TH-6

Zancor Homes

Wasaga Townhomes

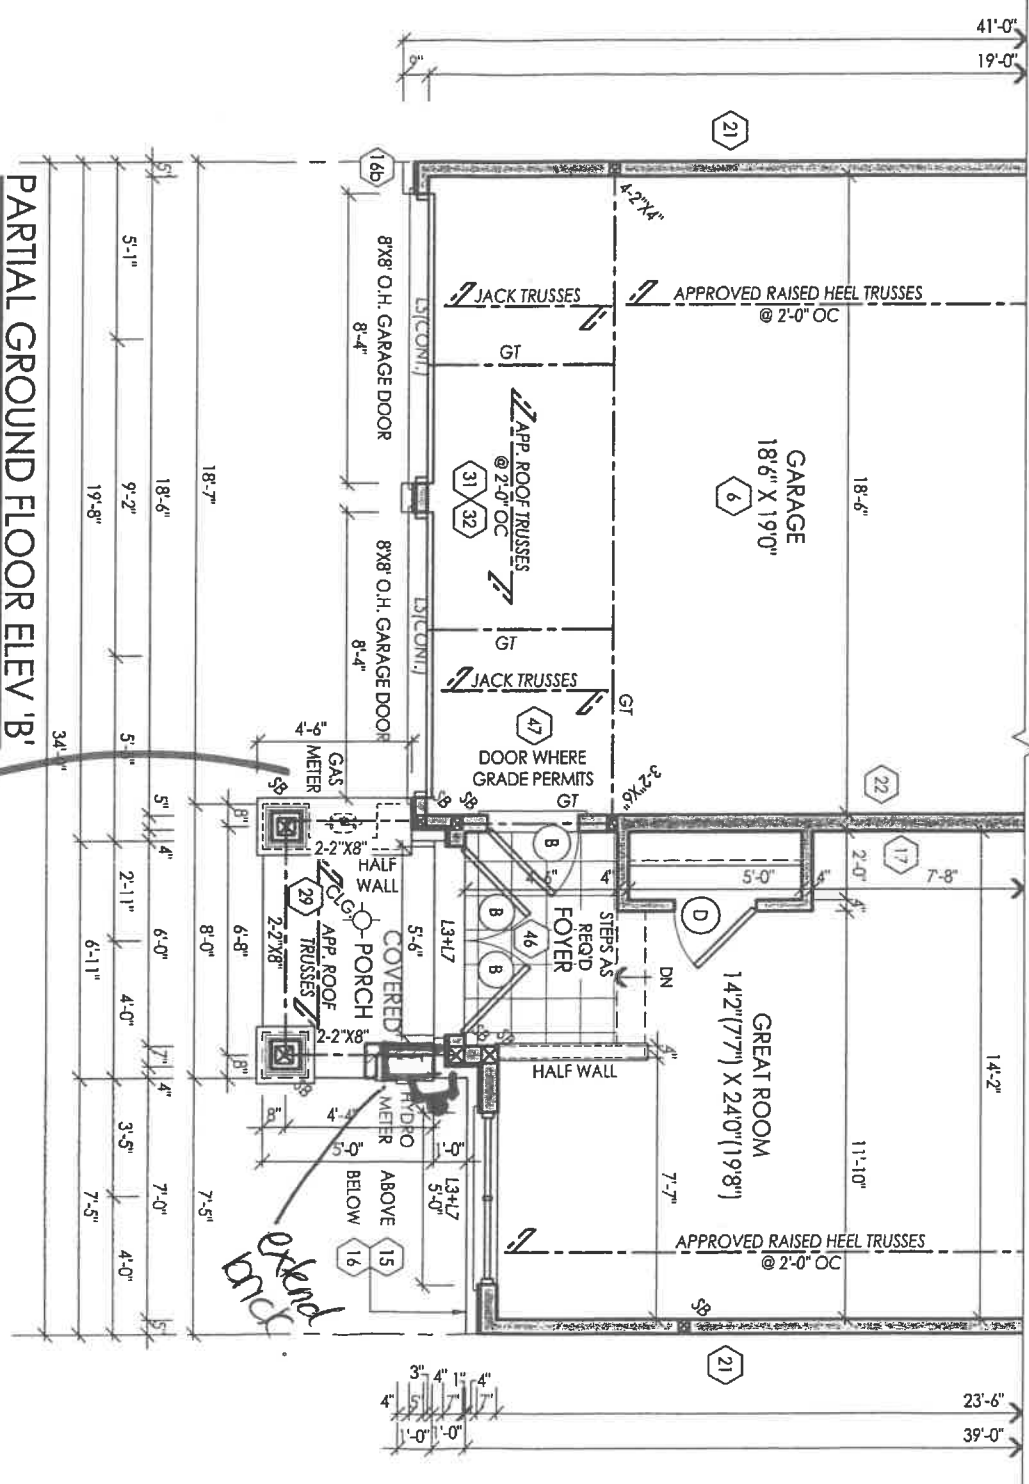
provide sump pump

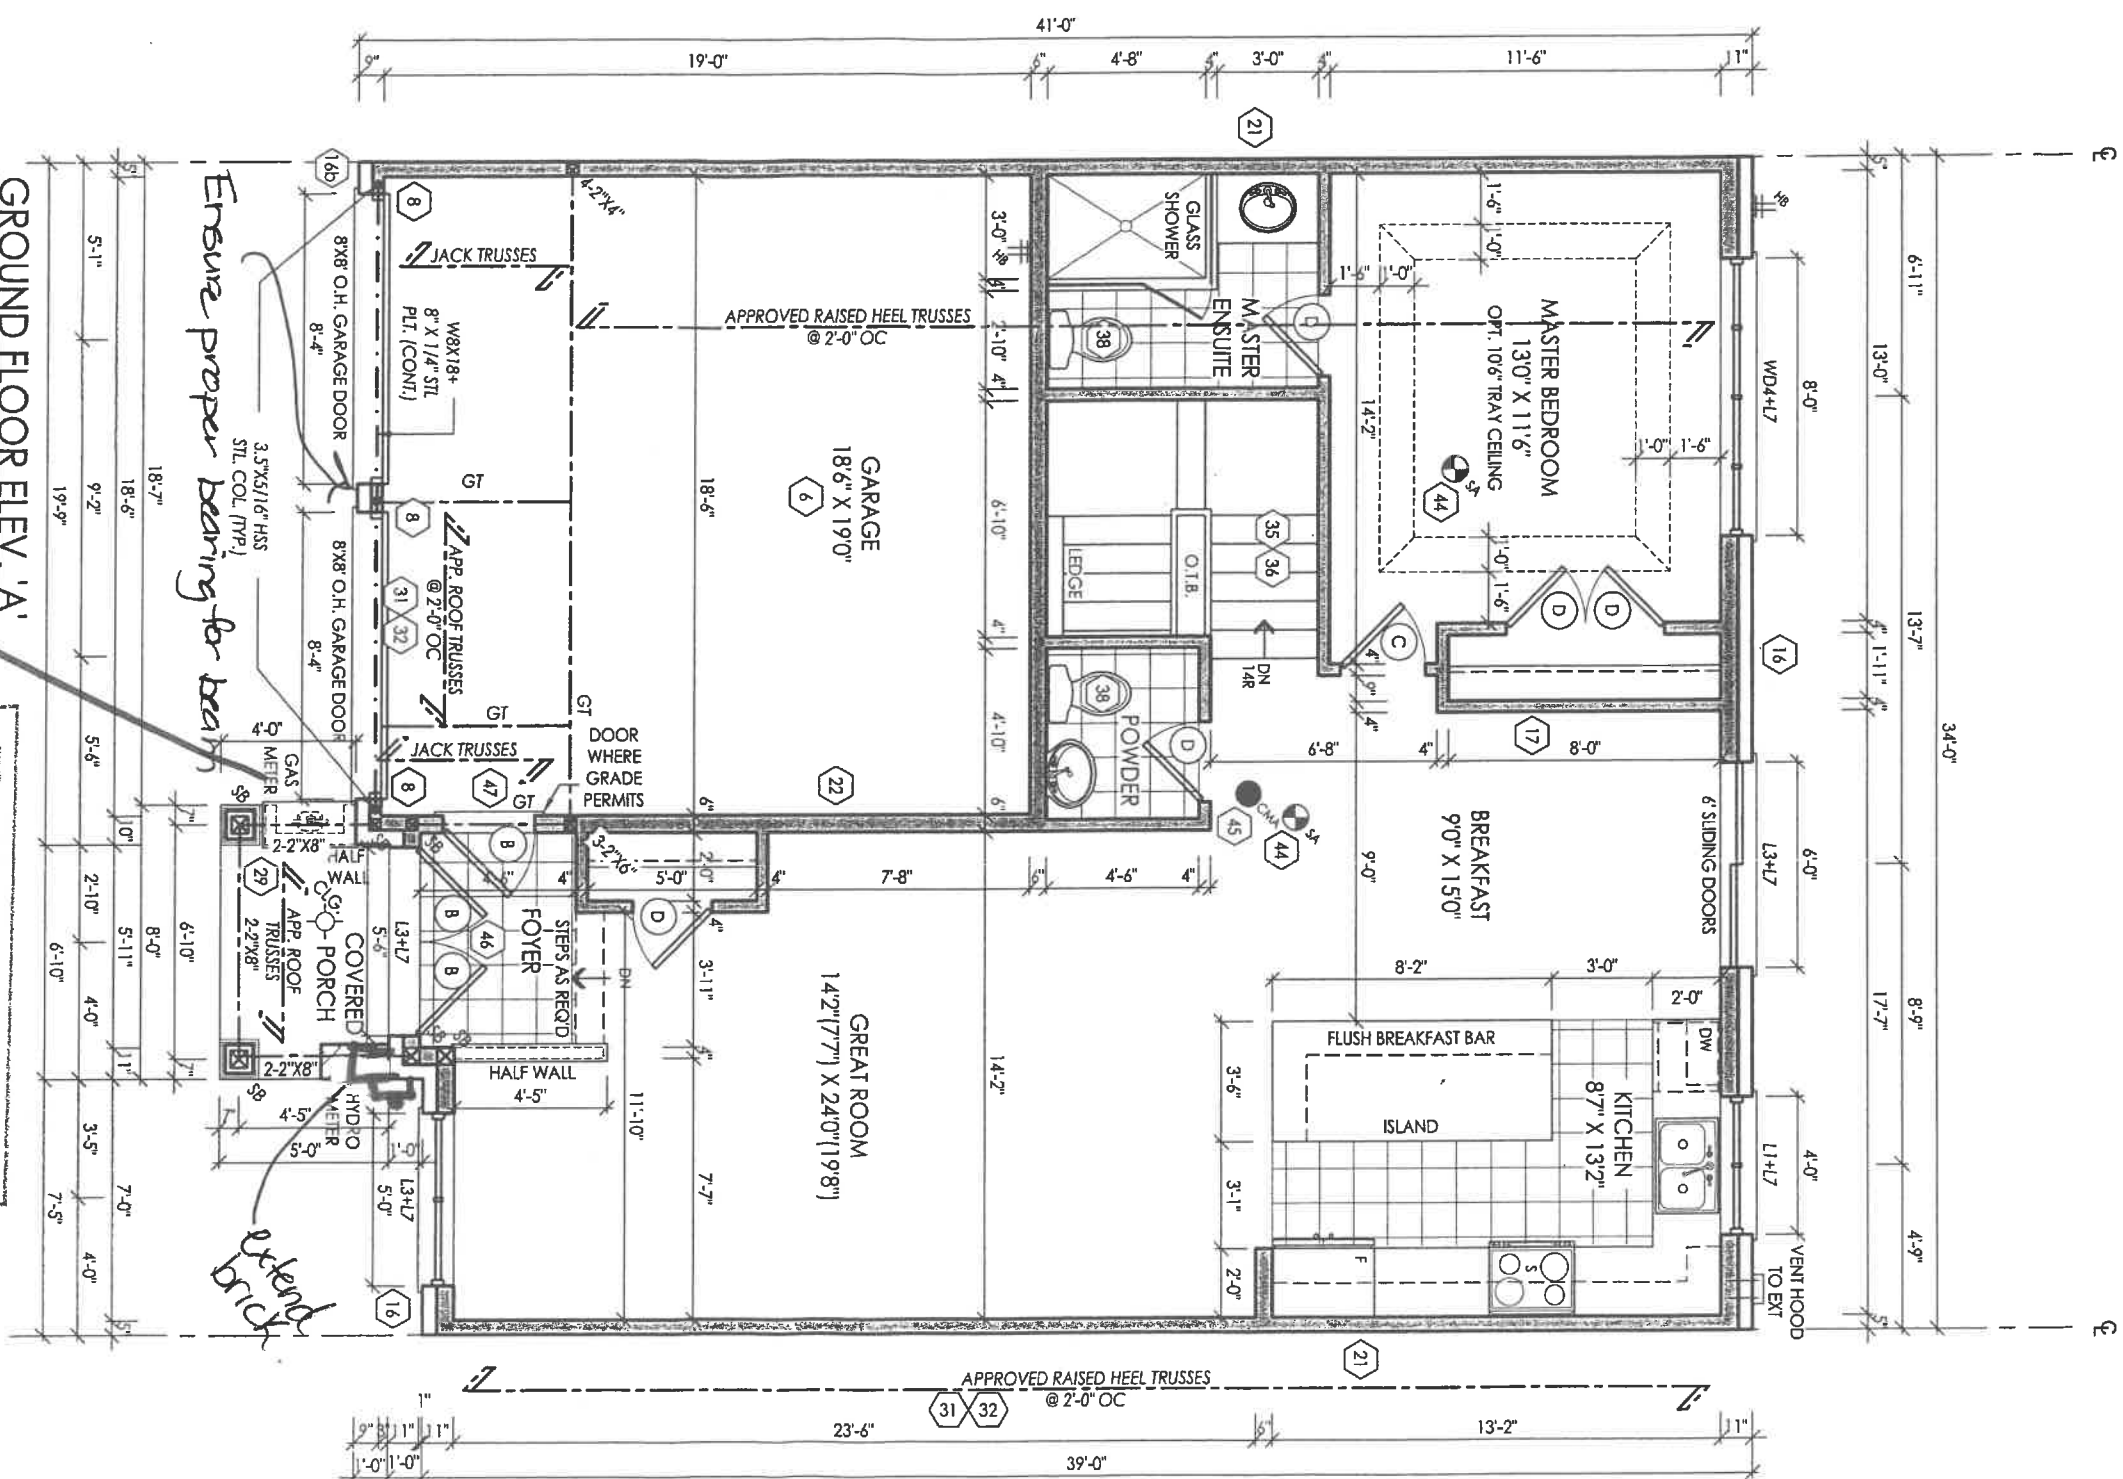
Handwritten note: mfg inside porch

Handwritten note: Ensure proper bearing for beam

Handwritten note: extend brick
